RE: Crystal Beach Renovation – Addendum #2

## CRYSTAL BEACH PRE-BID MEETING QUESTIONS

- A. Bidder: \_\_\_\_\_.
- B. Project Name: Crystal Beach Pool and Pool House Renovation
- C. Project Location: Madison, Indiana
- D. Owner: City of Madison, Indiana.
- E. Design Project Number: 20.0400
- F. Architect: KNBA Architects

AQ000

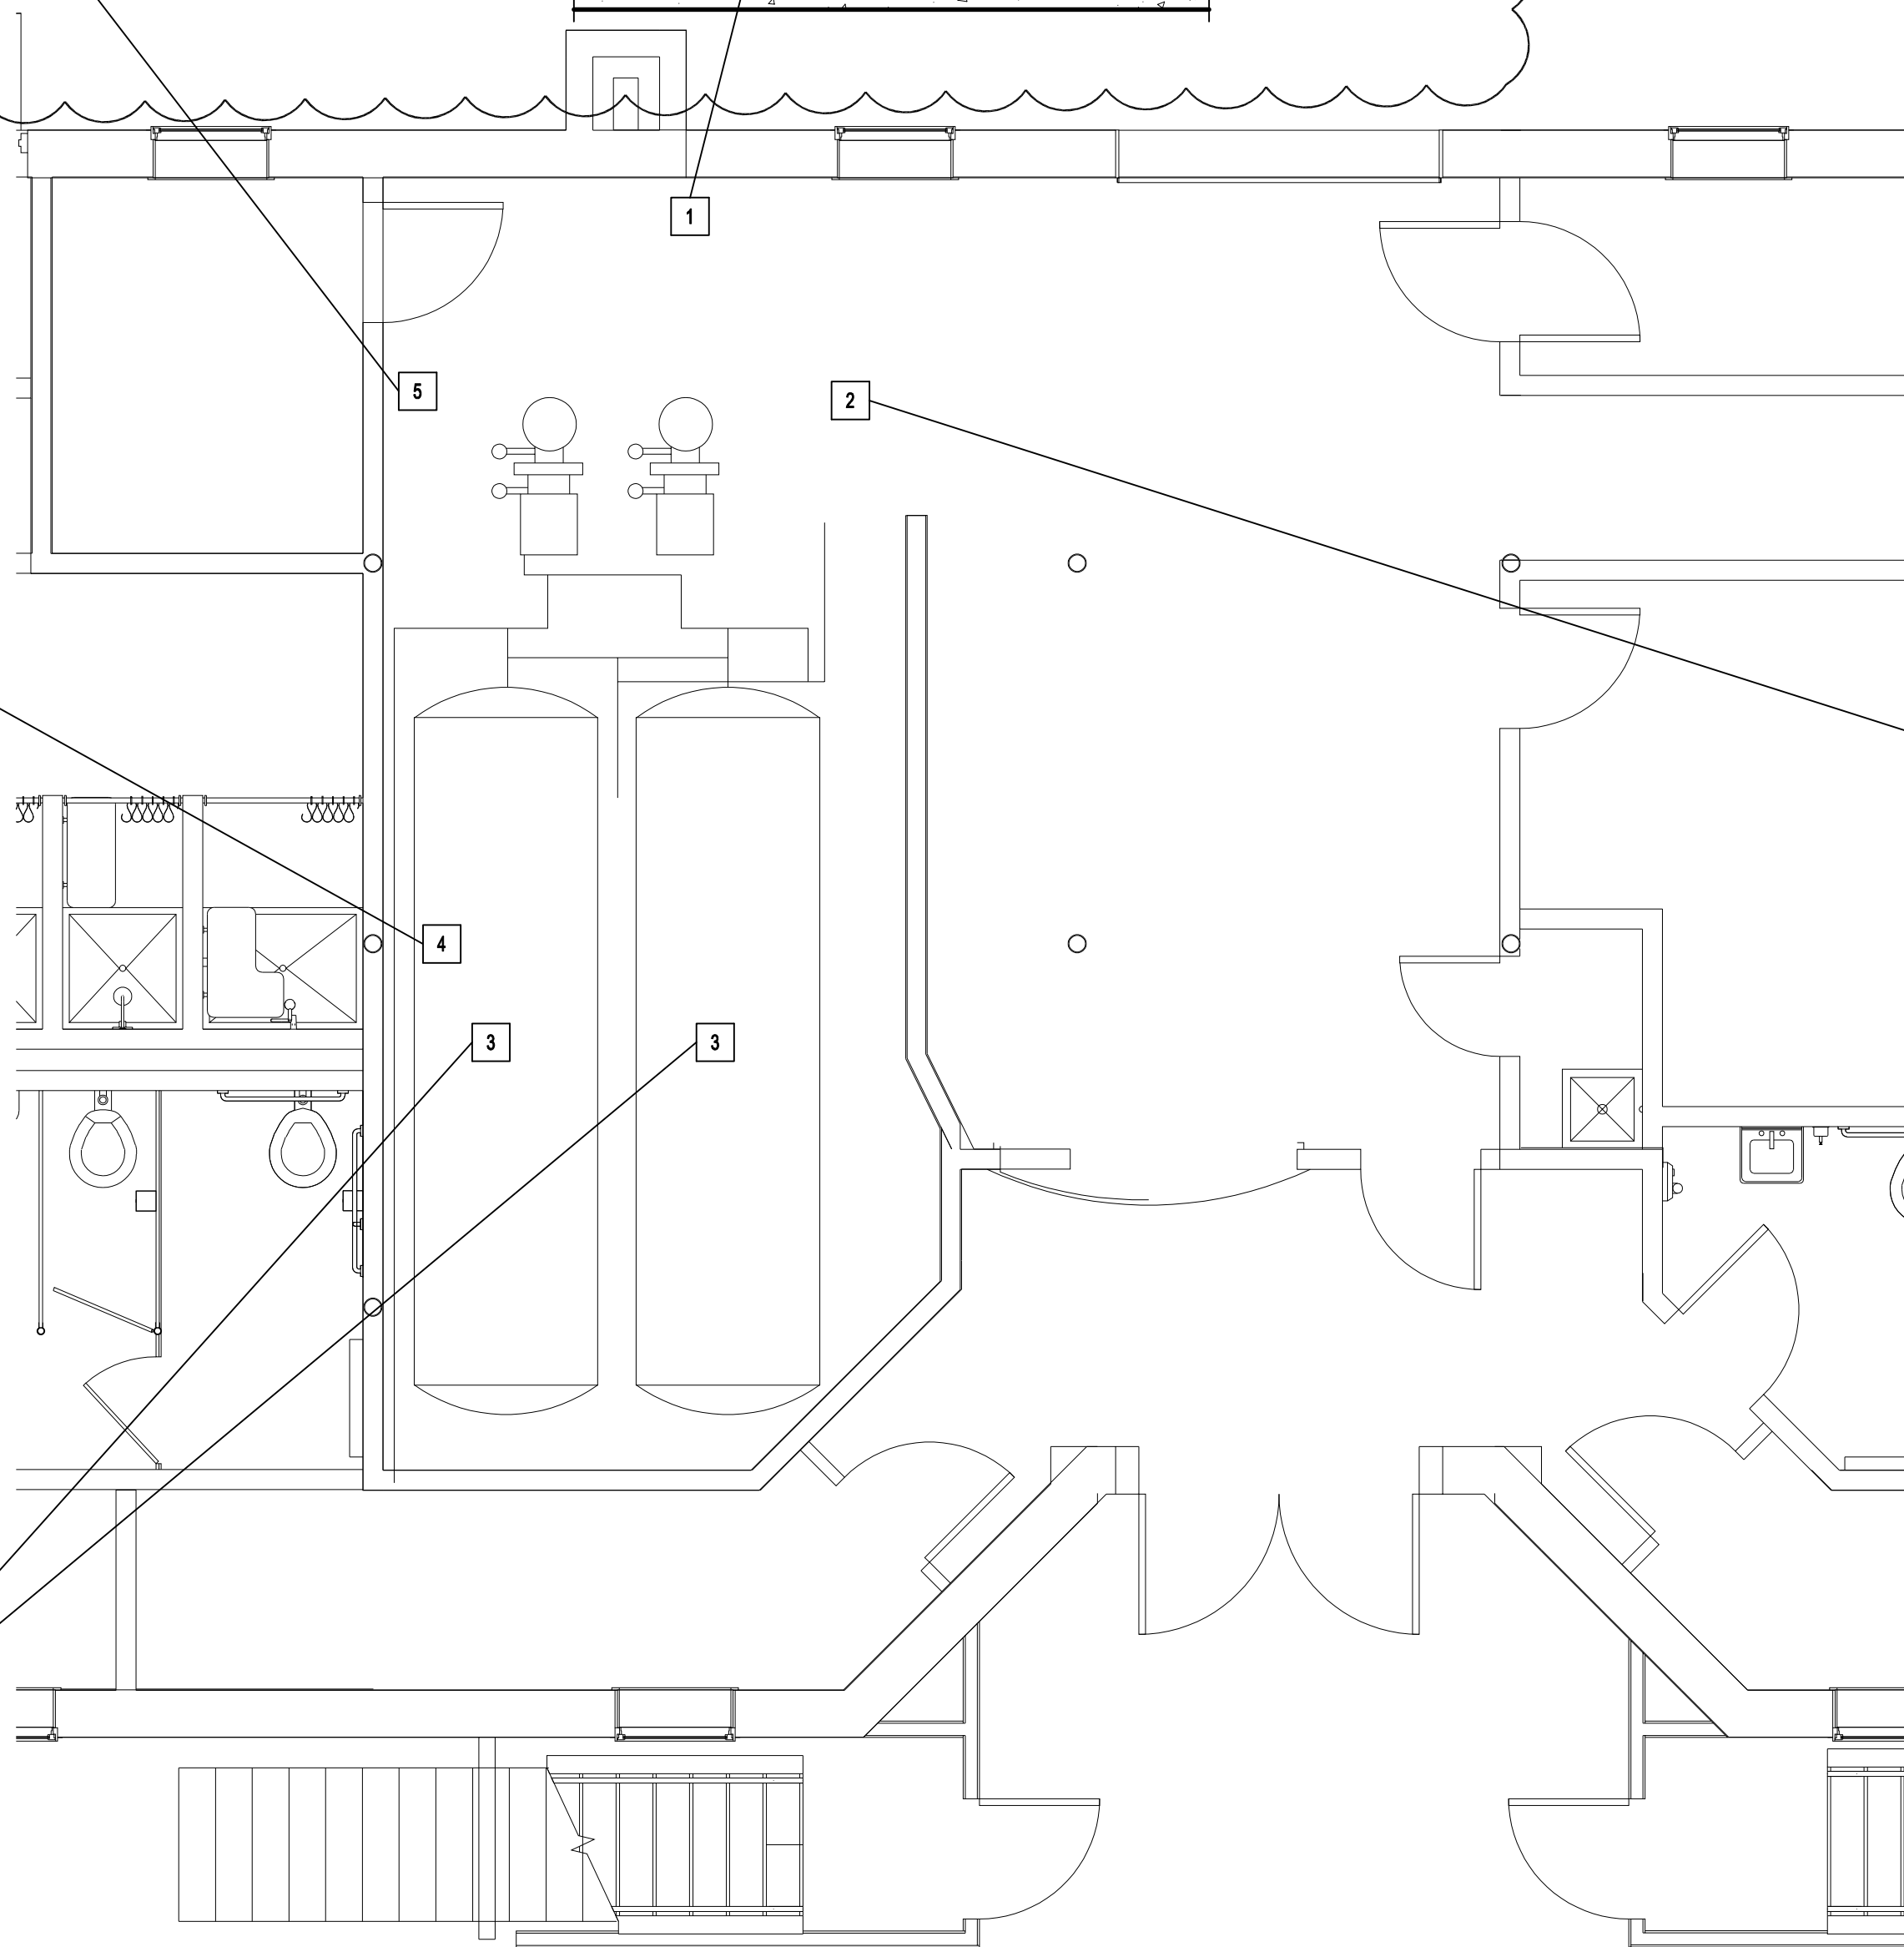
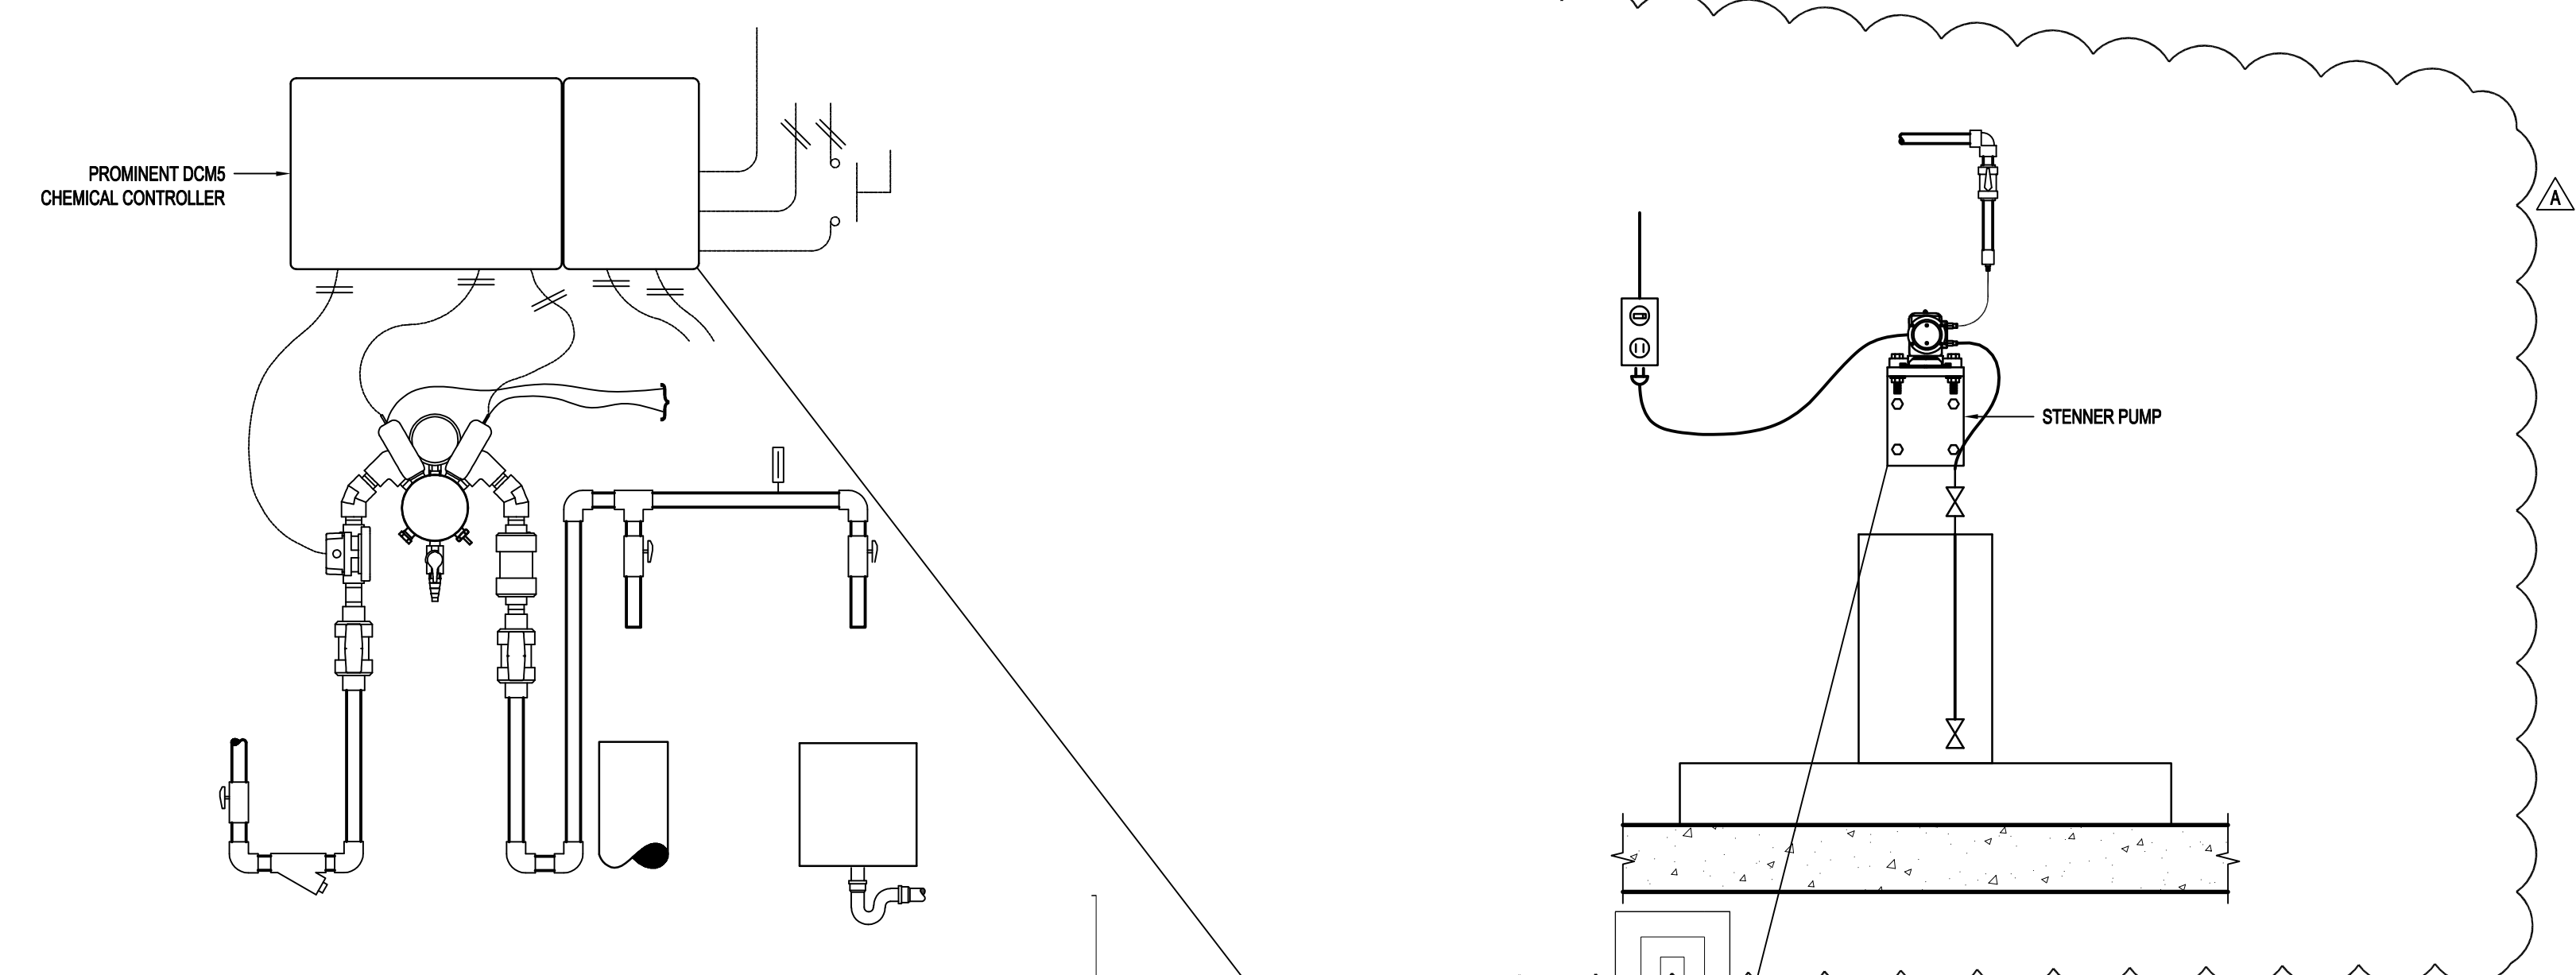
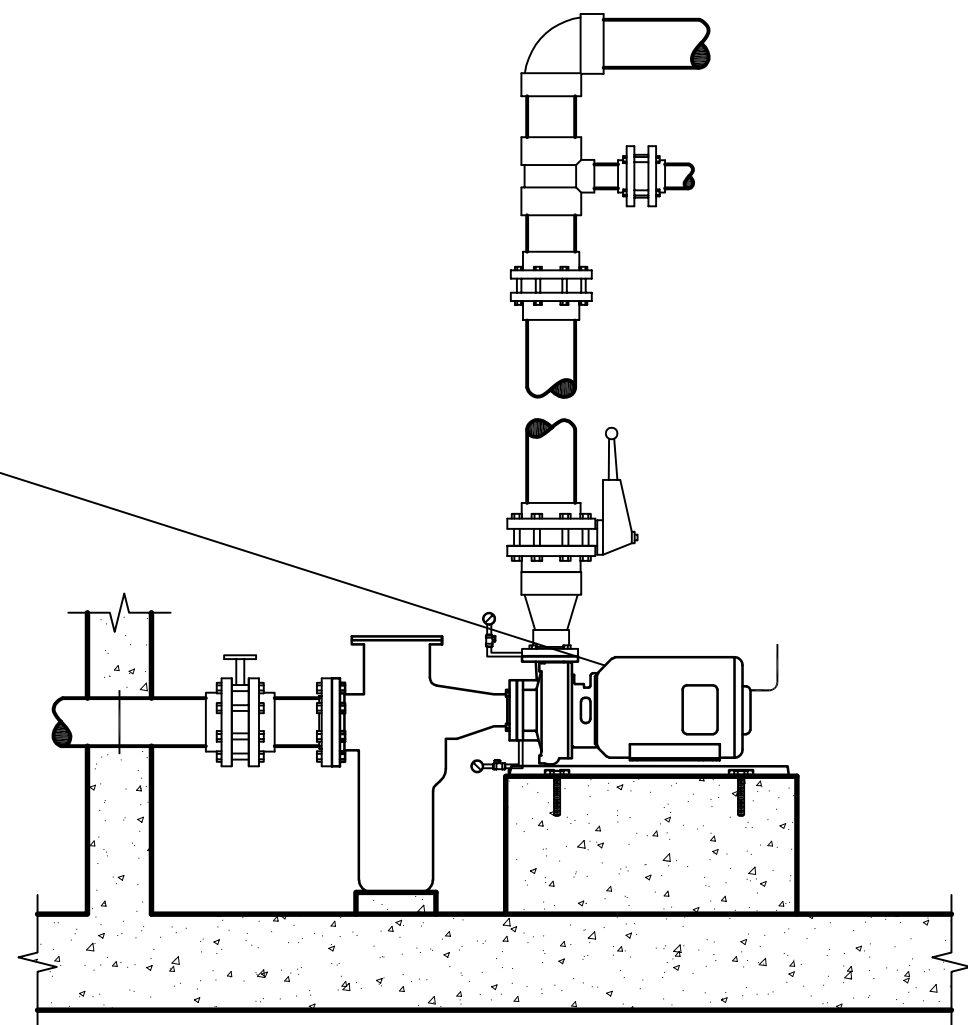
6	What are the depths of the existing pool?	Varies from 7'-6" to zero-entry.	POOL
7	What is the current turnover rate of the pool?	The filtration turnover period for the pool is 360 minutes at 1632 gallons per minute. There are 2 sand filters with a turnover rate of 14.06 gallons per minute per square foot.	POOL
8	Will all associated plumbing for new pool equipment need to be included in the pool scope or will all existing plumbing remain?	See attachments AQ000 and AQ100.	POOL
9	What size are existing main drains? What are the make and model?	Will need to be field verified.	POOL
10	What is the make and model of secondary pool lift requested?	Match similar type to current battery-powered lift on site.	POOL
11	What is the make and model of the PH system requested?	See attachment AQ100.	POOL
12	What are the existing pool filter makes and models?	Will need to be field verified.	POOL
13	What make and model of flow meter requested?	See attachment AQ100.	POOL

14	What make and model of chemical control system requested?	See attachment AQ100.	POOL

POOL MECHANICAL ROOM WORK	
1	INSTALL NEW PH FEED SYSTEM. PROVIDE NEW 1/2" PVC CHEMICAL FEED LINES. TWO (2) STENNER 88M5 PUMPS - TWO (2) 15 GAL. CARBOYS.
2	(1) INSTALL CONCRETE PUMP VOLUTE HOUSING SUPPORT. (2) EPOXY COAT OR REPLACE THE CONCENTRIC REDUCERS ON THE DISCHARGE FLANGE OF EACH PUMP.
3	(1) REMOVE FILTER EXISTING SAND AND INSTALL NEW FILTER SAND. (2) INSTALL NEW MANWAY GASKETS AND RECOAT MANWAY PRESSURE CLAMPS.
4	INSTALL NEW IMPACT FLOWMETER ON BACKWASH HEADER. BLUE WHITE F-300
5	(1) INSTALL NEW AUTOMATIC CHEMICAL CONTROLLER WITH FLOW CELL. (2) INSTALL NEW PH FEED SYSTEM. (3) PROVIDE NEW 1/2" SCH. 80 PVC CHEMICAL FEED LINES.
